Certificate of Appropriateness Request:

H-02-23

40 Franklin Ave NW

Staff Report prepared by:

② East
1/4" = 1'-0"

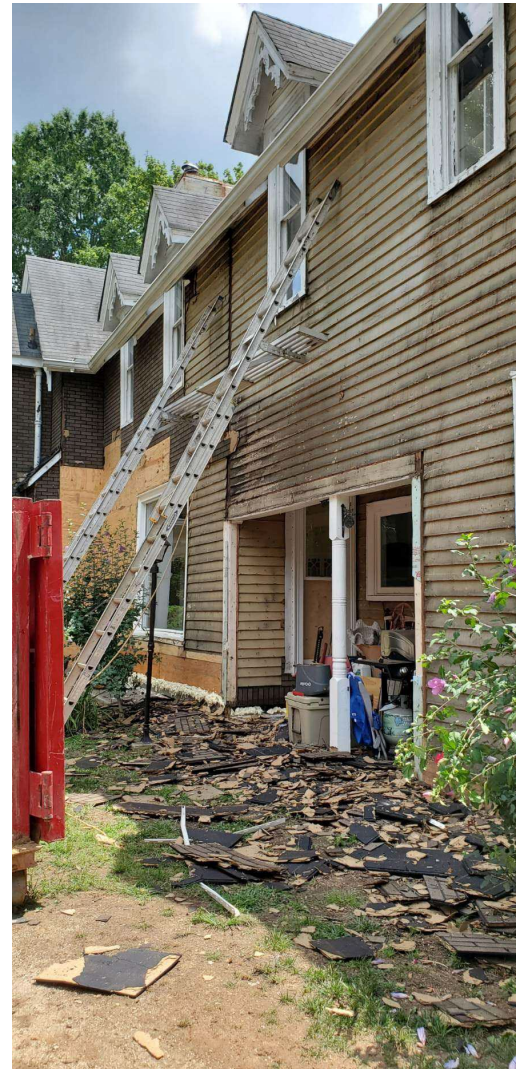
- 6) The new elevation drawings of submission, show the variation; vertical trim boards define the areas of alteration and separate original from new.
- 7) The sill band trim will be restored, and altered spaces to match the original.

NOTE: WINDOWS = SALVAGED ORIGINALS

Plate glass window to be replaced with salvaged originals

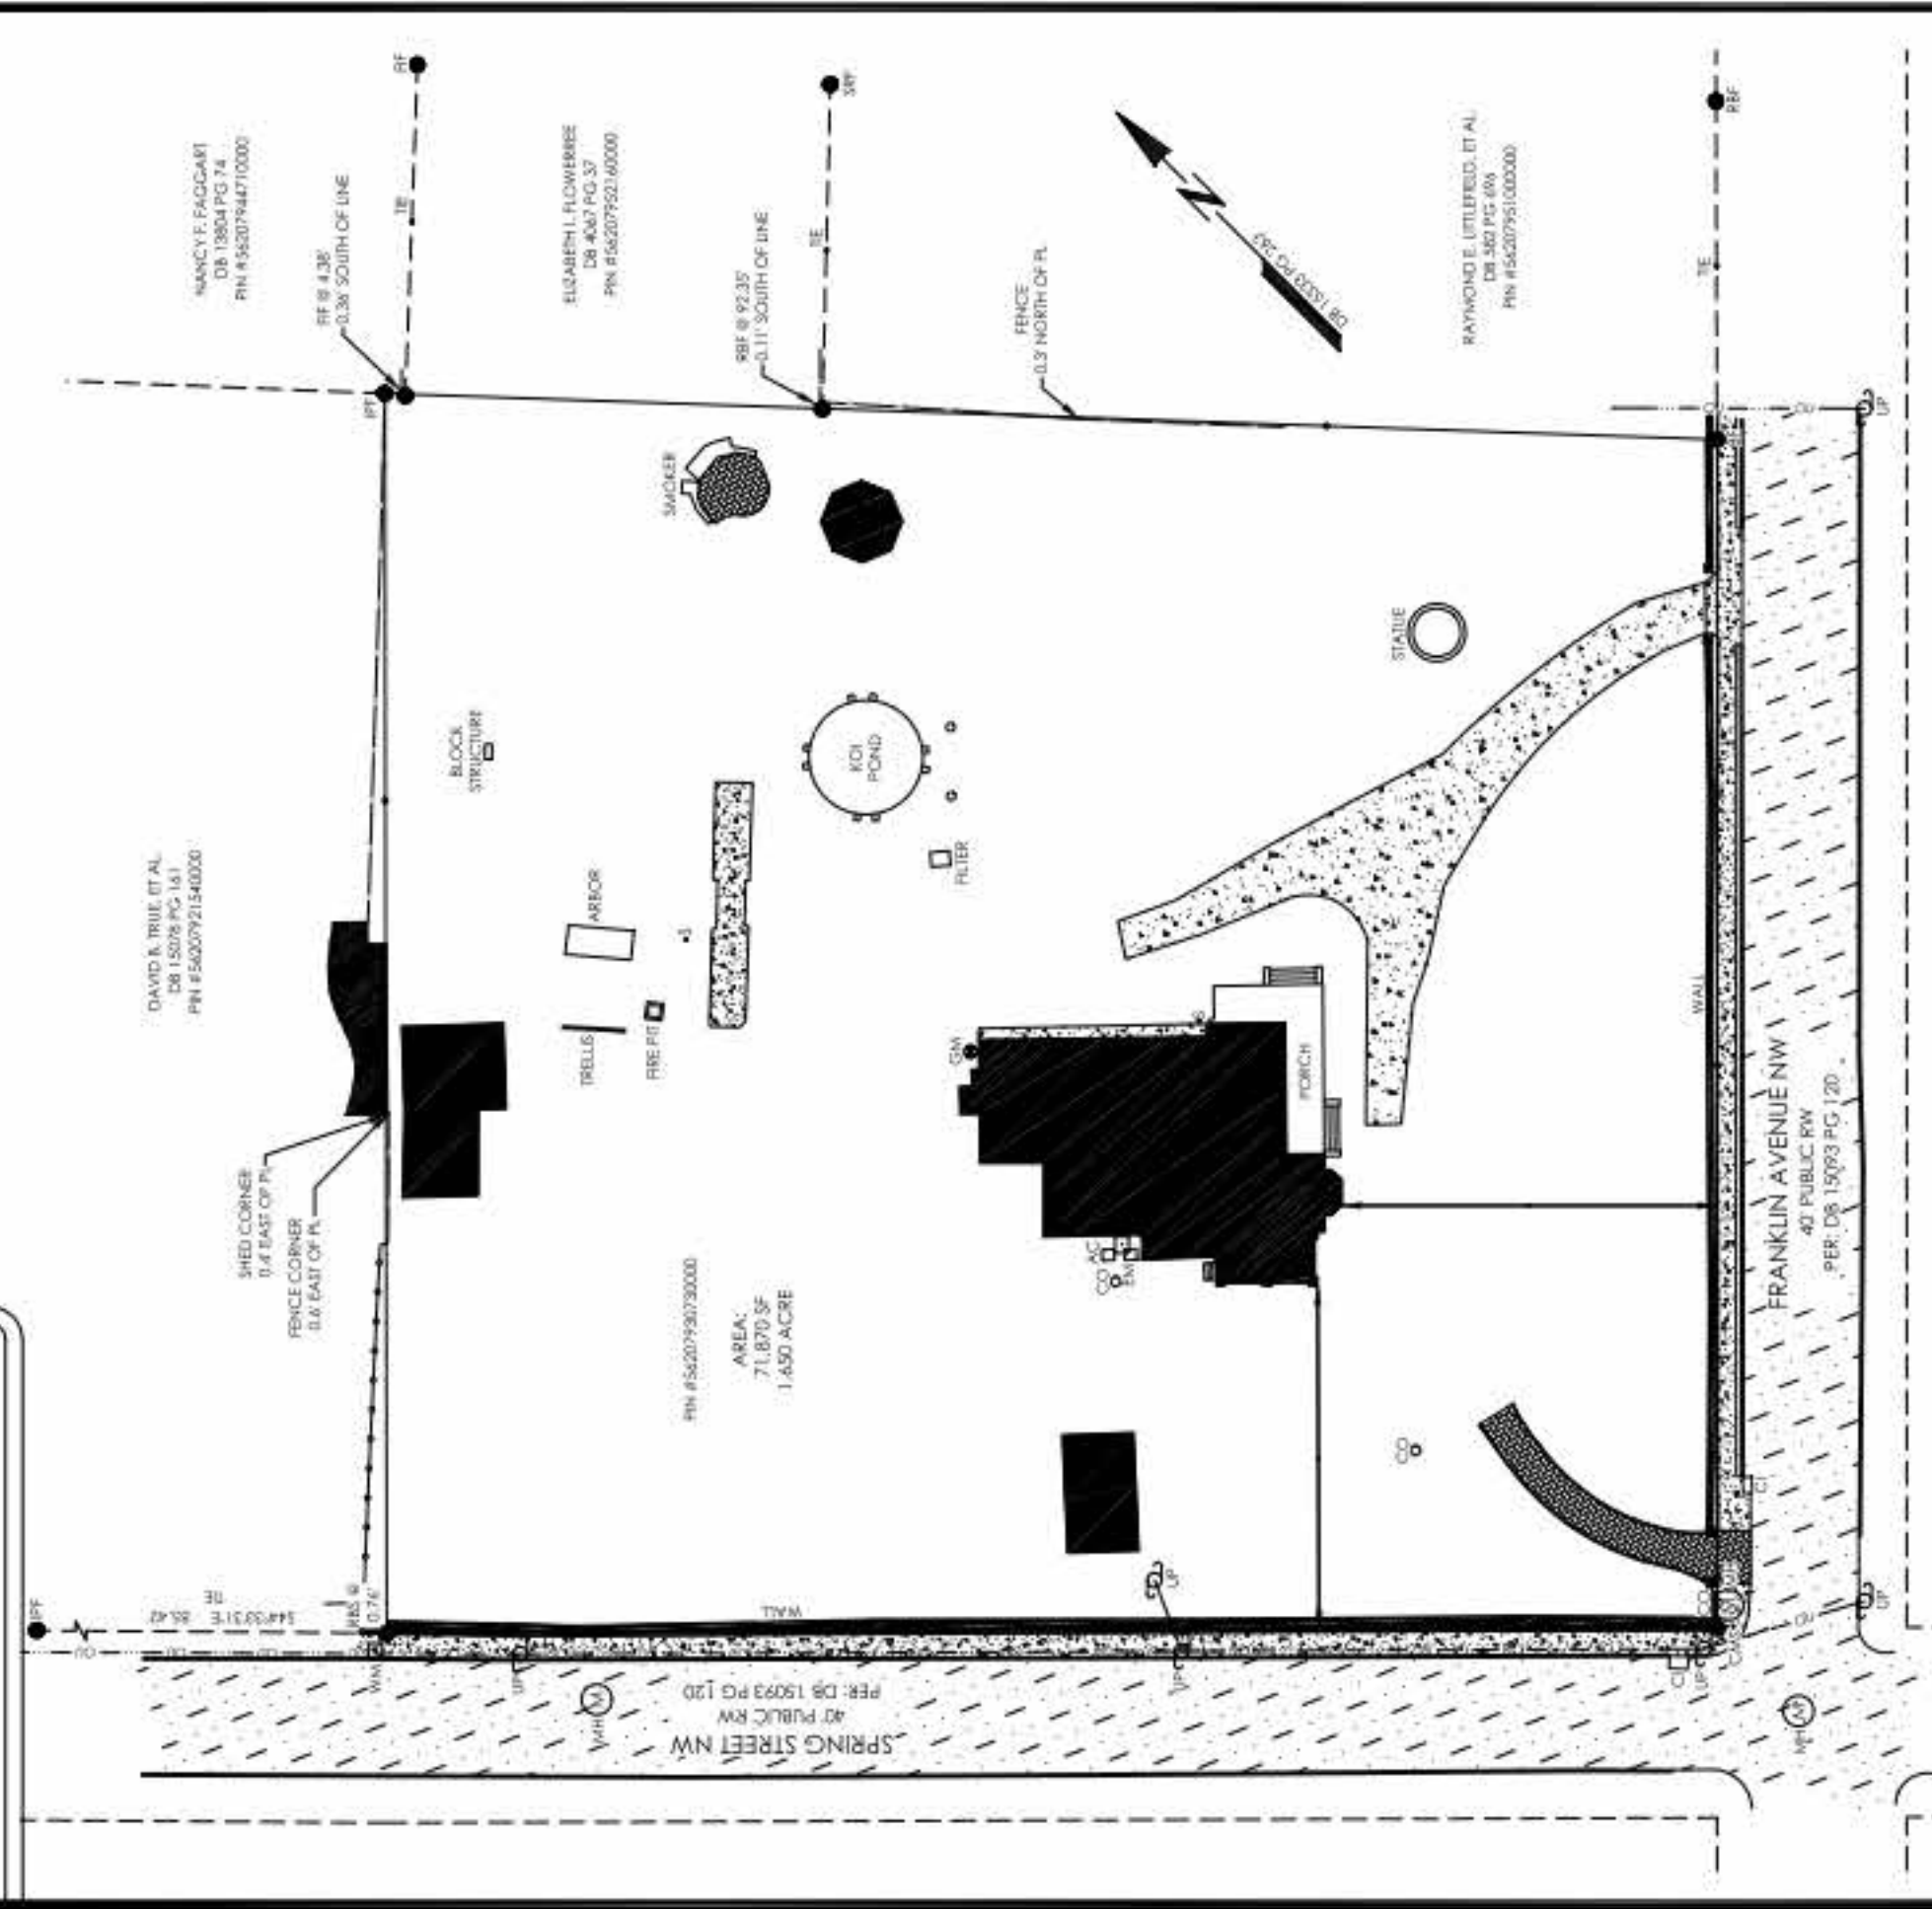
Inside corner with water filtration problem

③ B&B SIDING DETAIL
1/4" = 1'-0"

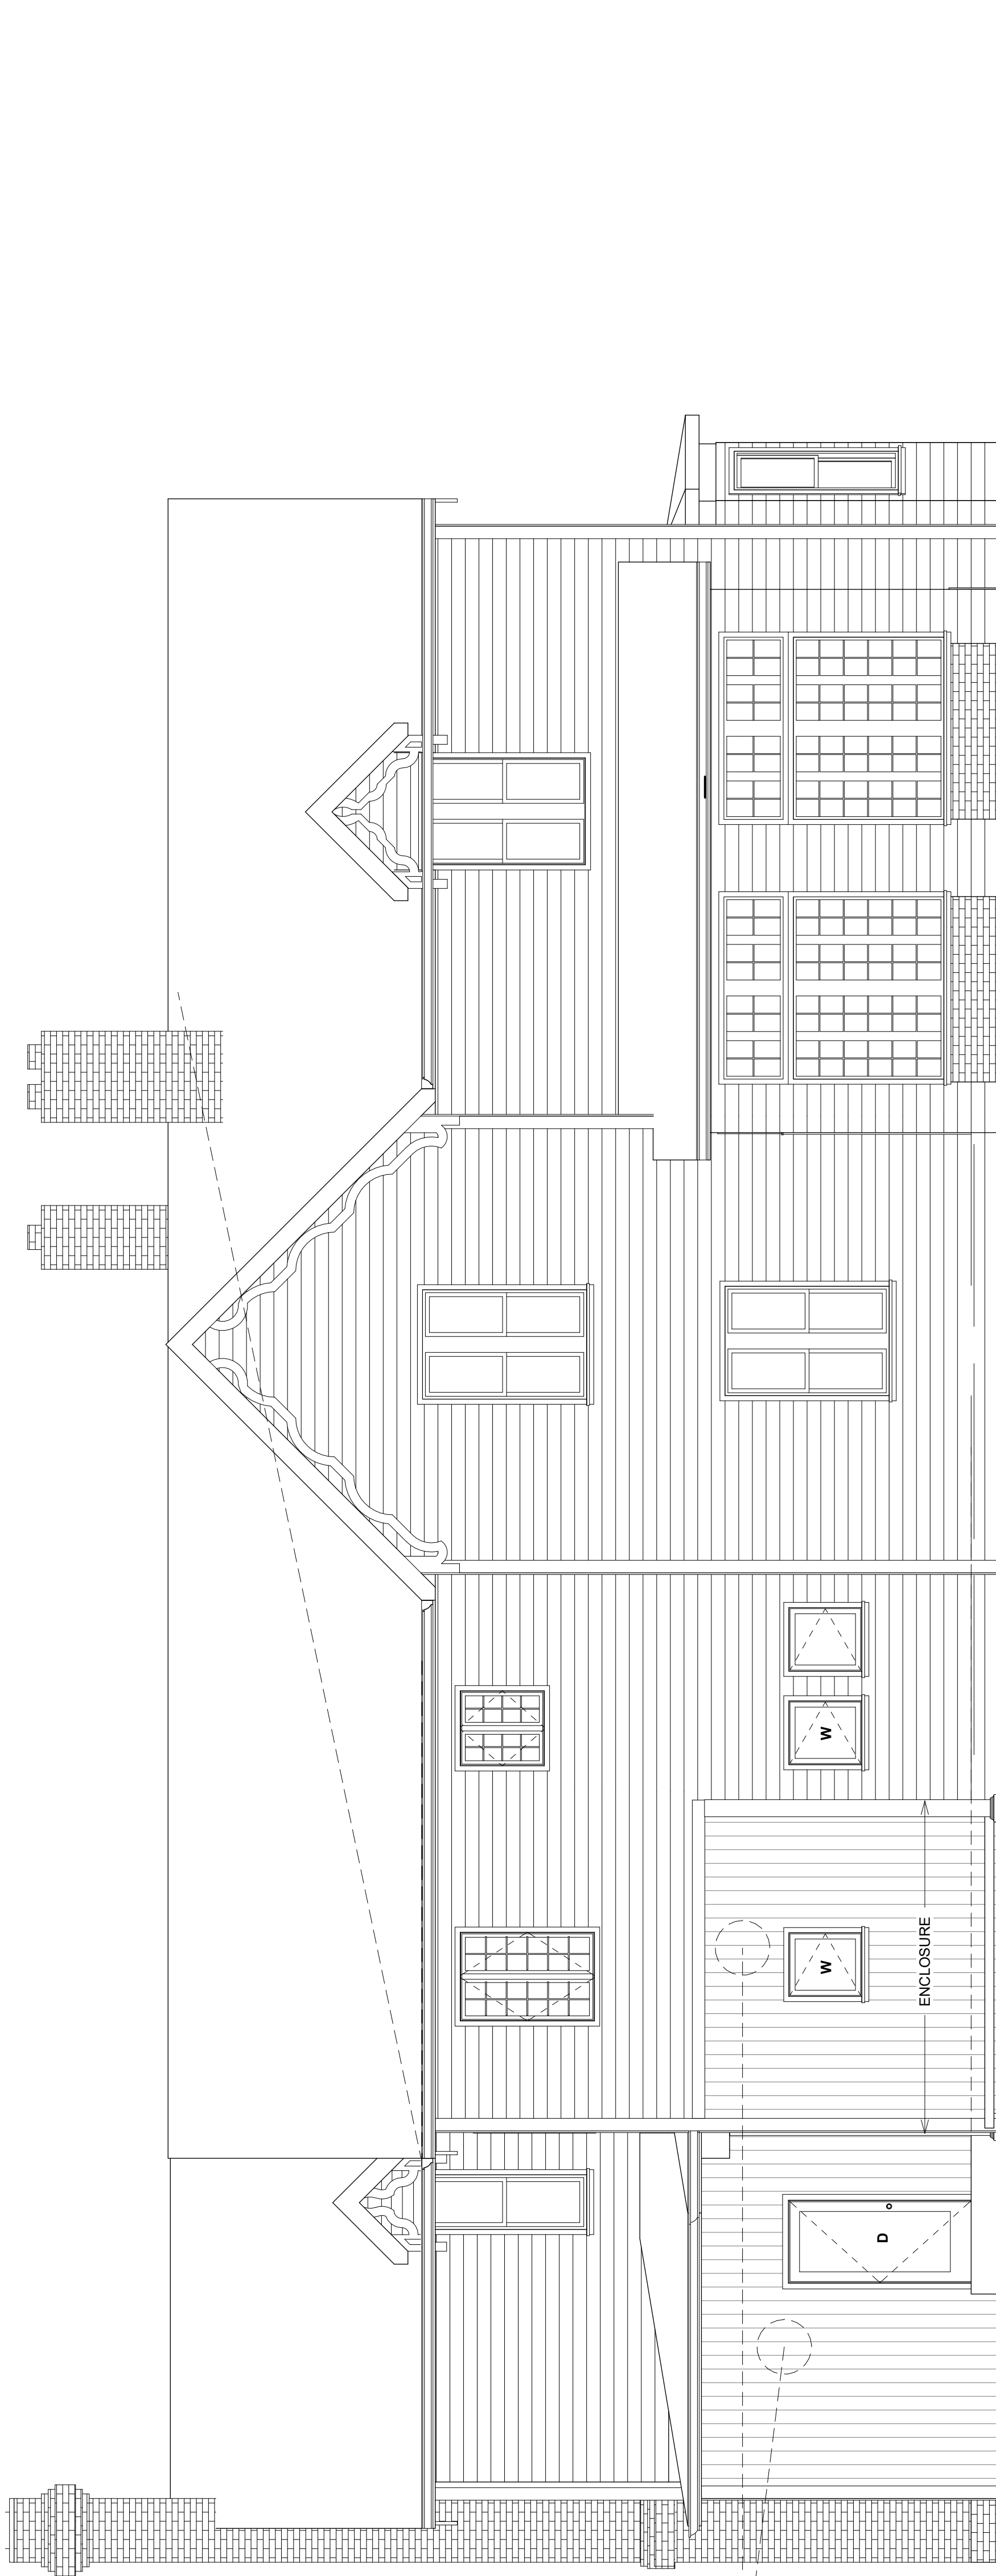
- E. The replacement of the non-original siding with Board and Batten siding on the north (rear) elevation is appropriate as it does remove non-original siding and restore original siding and is in compliance with the Historic Handbook.

② East
1/4" = 1'-0"

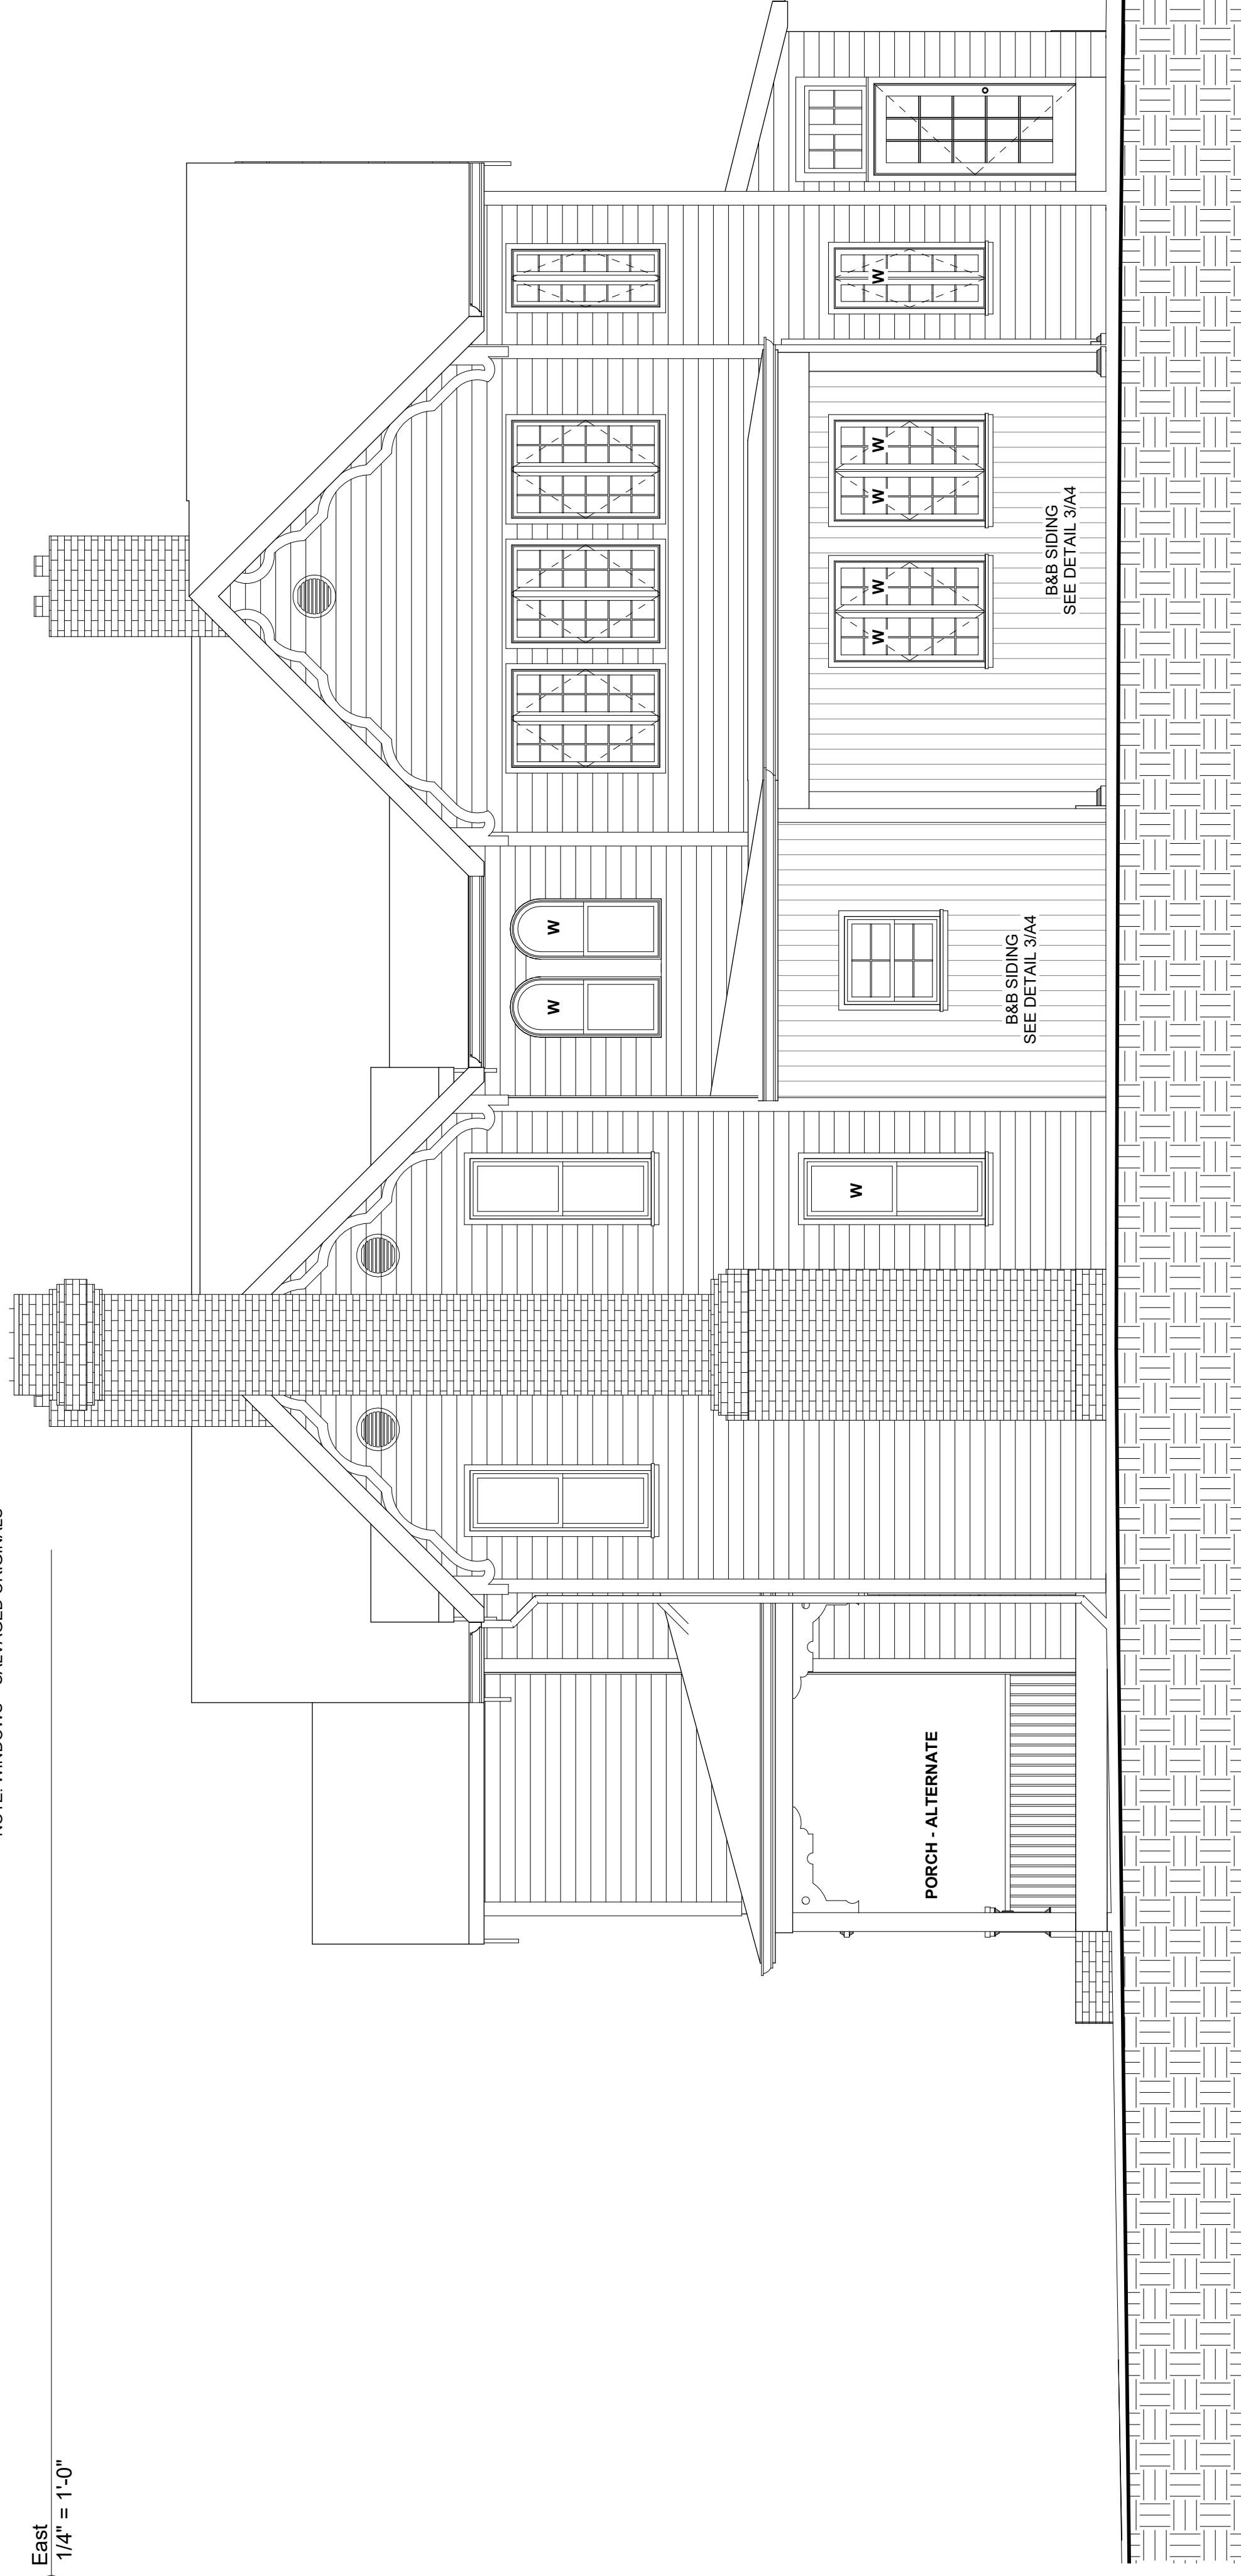
PORCH INSTEAD OF CARPORT & CONNECTING PORCH W/ NO RAILING
